UNITED STATES PATENT AND TRADEMARK OFFICE

APPLICATION NO.	FILING DATE	FIRST NAMED INVENTOR	ATTORNEY DOCKET NO.	CONFIRMATION NO.
10/624,338	07/22/2003	Clayton M. Grondahl	GRON-0002	6985
23550 7590 12/31/2007 HOFFMAN WARNICK & D'ALESSANDRO, LLC 75 STATE STREET 14TH FLOOR ALBANY, NY 12207			EXAMINER REESE, DAVID C	
			ART UNIT 3677	PAPER NUMBER
			NOTIFICATION DATE 12/31/2007	DELIVERY MODE ELECTRONIC

Office Action Summary	Application No. 10/624,338	Applicant(s) GRONDAHL, CLAYTON M.	
	Examiner David C. Reese	Art Unit 3677

DETAILED ACTION

With respect to claims 1, 9, 19, and 24, Gail discloses of a seal assembly (see figure below) comprising:

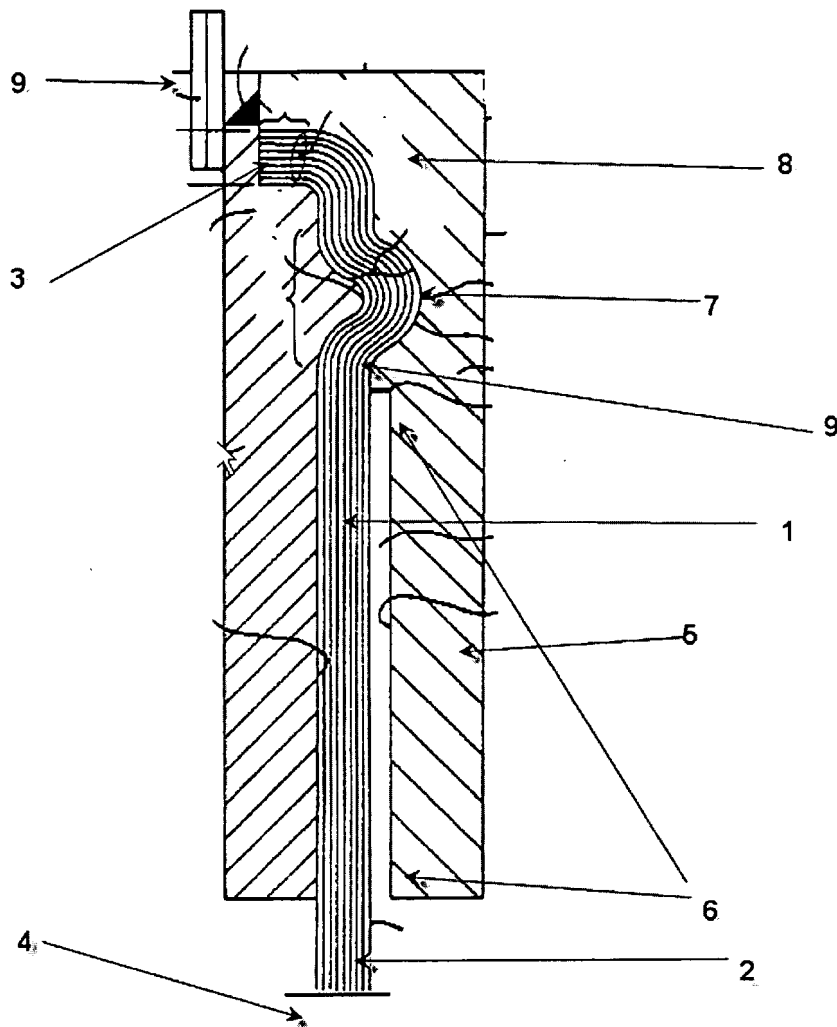
a brush seal (1) with a plurality of staggered seal members, each brush seal member including:

a free portion (2) [adapted to be]* angled relative to a longitudinal axis and longitudinally angled relative to all radial axes of a component (4) to be sealed against; and

a fixed portion (3) that is angled relative to free portion (2) and [adapted to be]* one of substantially parallel to and substantially perpendicular to the longitudinal axis of the component (4) to be sealed against; and

a support (5) coupled to a low pressure side of the seal for supporting the free portion (2), the support (5) having a support portion facing a high pressure side of the seal,

wherein the free portion (2) contacts a distal end (6) in an pressurized operative state (*) and is out of contact with the distal end (6) in an unpressurized inoperative state, the fixed portion (3) of the seal is angled relative to the free portion (2) in both the operative and inoperative states, and the free portion (2) is adapted to be closer to the component (4) to be sealed against during the pressurized operative state than in the unpressurized inoperative state (*).

Re: Claim 3, wherein the support portion (5) includes a curved surface (7) extending from a proximate end (8) of the support portion (5) to the distal end (6), and the free portion (2) extends tangentially (9) from the curved surface in the operative state.

Re: Claim 4, wherein the proximate end (8) is coupled to a mount portion (9) of the support that mounts the support (5) to a stationary component.

Re: Claim 8, wherein the fixed portion (3) is positioned substantially perpendicular to a longitudinal axis of a component (4) to be sealed, and the free portion (2) is angled out-of-plane relative to the fixed portion (3).

Re: Claim 11, wherein the distal end (6) of the support (5) portion is thinner than a proximate end (8) of the support portion, and the proximate end (8) is in contact with the free portion in the inoperative state (at 9).

Re: Claim 12, wherein the support portion (5) includes a curved surface (7) extending from a proximate end (8) to the distal end (6).

Re: Claim 13, wherein the proximate end (8) is coupled to a mount portion (9) of the support that mounts the support (5) to a stationary component.

Re: Claim 15, further comprising a holder for mounting the seal assembly to a stationary component, wherein the holder includes a projection for protecting the free portion (see area below and around 8 in the figure above).

Re: Claim 21, wherein the support portion (5) includes a curved surface (7) extending from a proximate end (8) to the distal end (6).

Re: Claim 23, wherein the fixed portion (3) is positioned substantially perpendicular to a longitudinal axis of a component (4) to be sealed, and the free portion (2) is angled out-of-plane relative to the fixed portion (3).
